Technical Note – Response to Comments

Project: 4274 - The Old Butcher's Block, Climping

This technical note has been prepared in response to the surface water drainage comments issued by Arun District Council's reviewing engineer (Ref: CM/11/26/DOC, ADC/EXT02, dated 22 June 2026), raised in respect of the discharge of Condition 3 (Surface Water Drainage) attached to planning permission CM/12/25/PL.

CCTV Survey was carried out on the road gully.

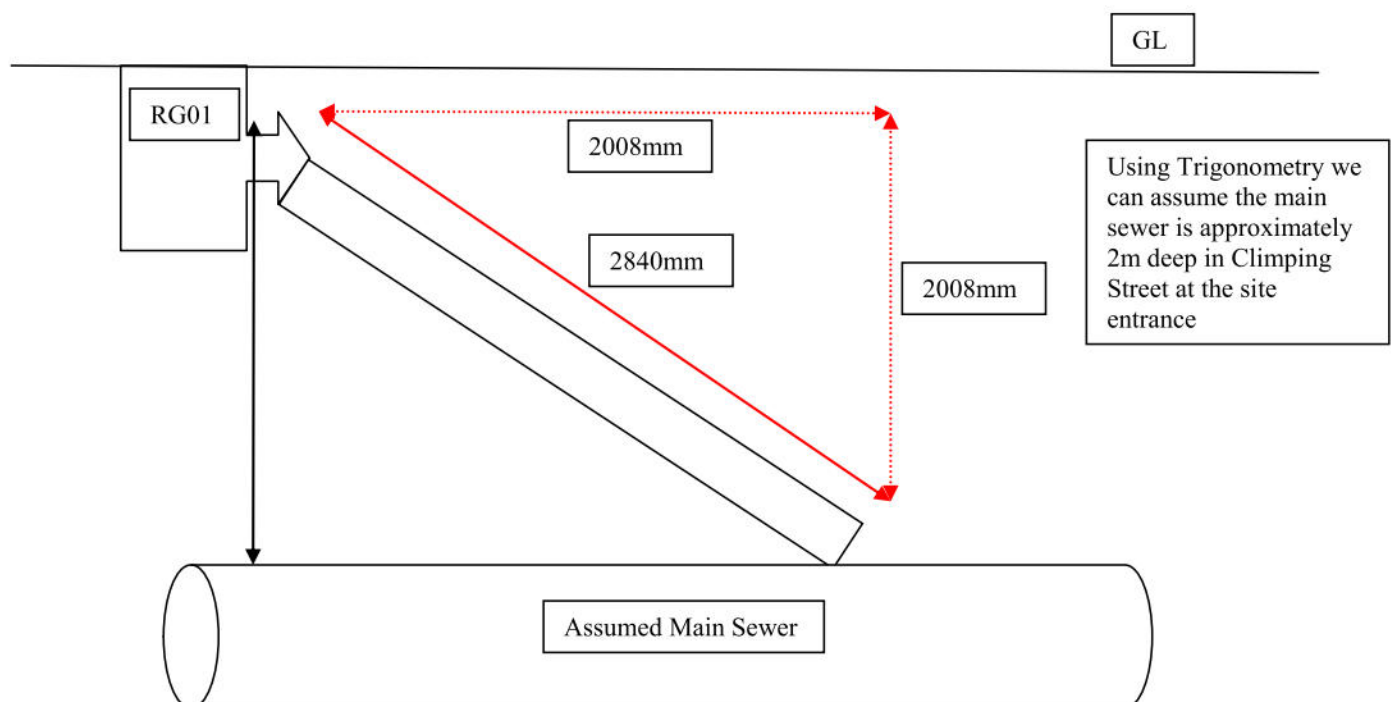
- 1.4. Additionally, there does not appear to be any assessment that the proposed development can drain by gravity to the existing public sewer (it is noted that limited information regarding the public surface water sewer is included in the public sewer records).

Surveys of the existing sewer network have been carried out and appended to this letter. From this survey information, it has been concluded that the depth to the public sewer is approximately 2m below the existing land levels at the entrance to the site. This is more than enough depth for the proposed connection to be made via gravity in this case. In addition, it is intended to construct a new manhole to replace the existing failed connection from a gully to the sewer that currently exists at the site entrance.

4274.DWG.d4
SURFACE WATER DRAINAGE
LAYOUT
HC-4274-501

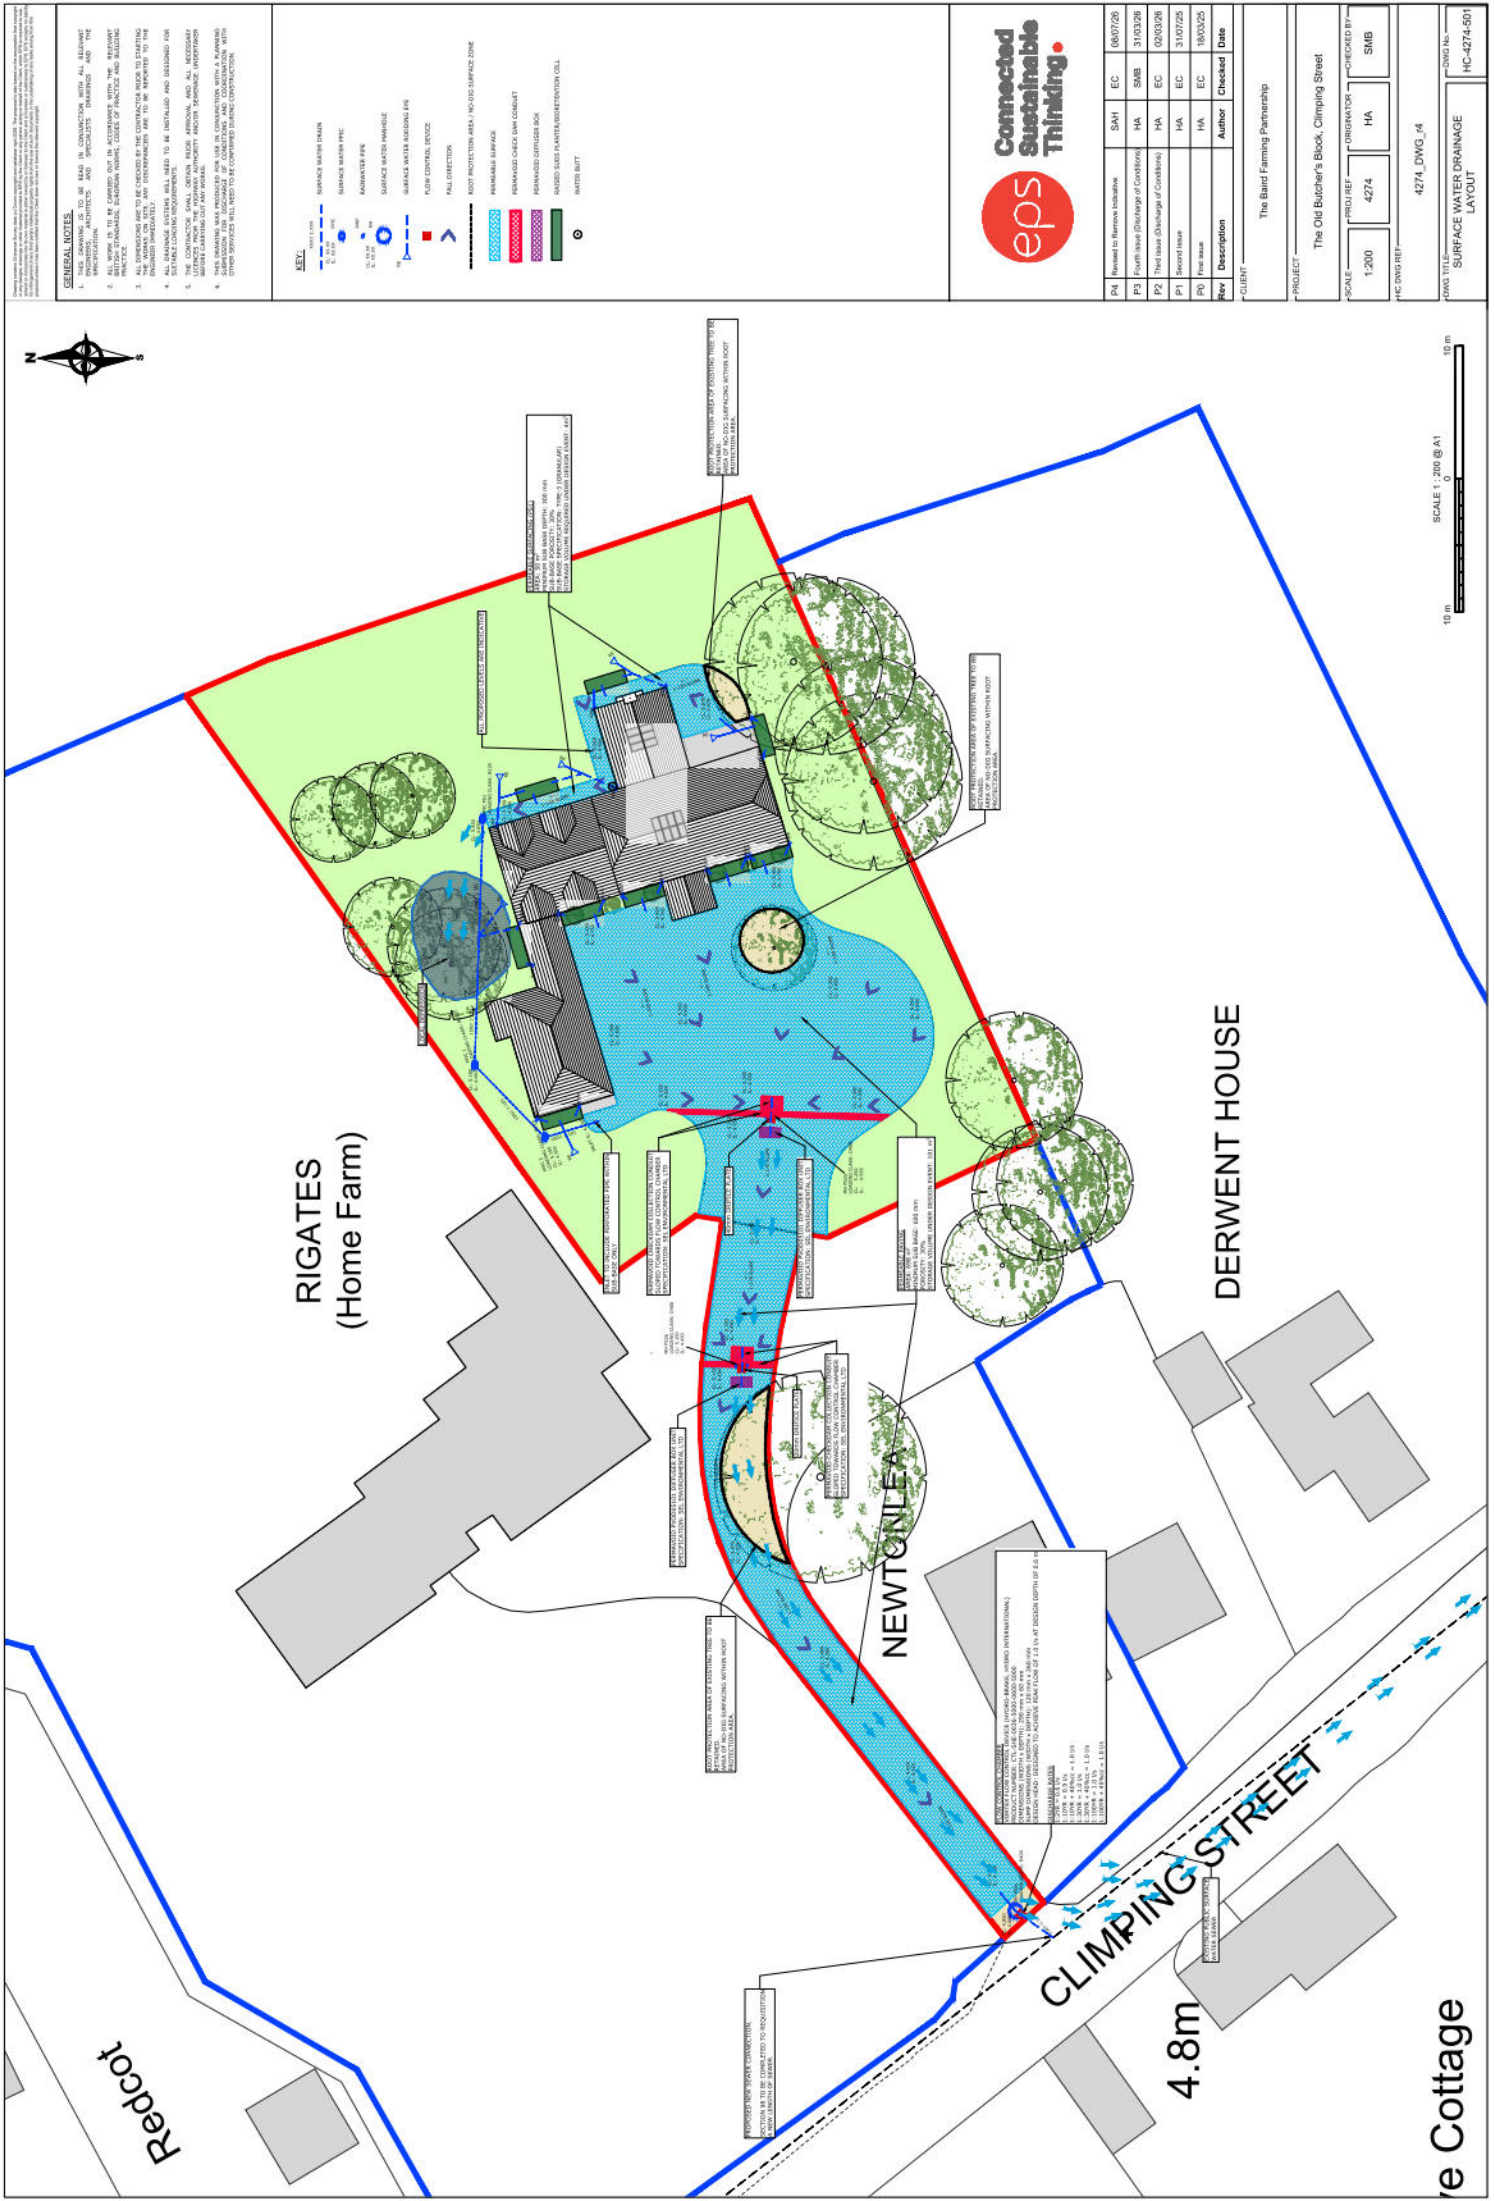
- 2.3. The inclusion of permeable paving when it drains its own catchment is considered to provide an adequate level of interception, however the plan appears to show the runoff from the roof connected to the permeable paving. Further interception measures may be required for the roof run-off, if evidence of evapotranspiration cannot be provided for the downpipe/SuDS planters.

The permeable paving provides interception for its own contributing (hardstanding) catchment. However, because infiltration has been discounted across the site due to seasonally high groundwater (see response to Standard 1 above), the paving is expected to require an impermeable liner. Under Standard 2, a lined permeable surface that also drains an additional impermeable area, such as a roof, is not deemed to achieve interception compliance for that additional area without further downstream measures.

To address this, roof runoff is routed through the downpipe/SuDS planters described in Section 2.2 ahead of entering the permeable paving sub-base. The planters provide interception for the roof catchment, with only interception-exceedance flows passing to the paving for onward attenuation and controlled discharge.
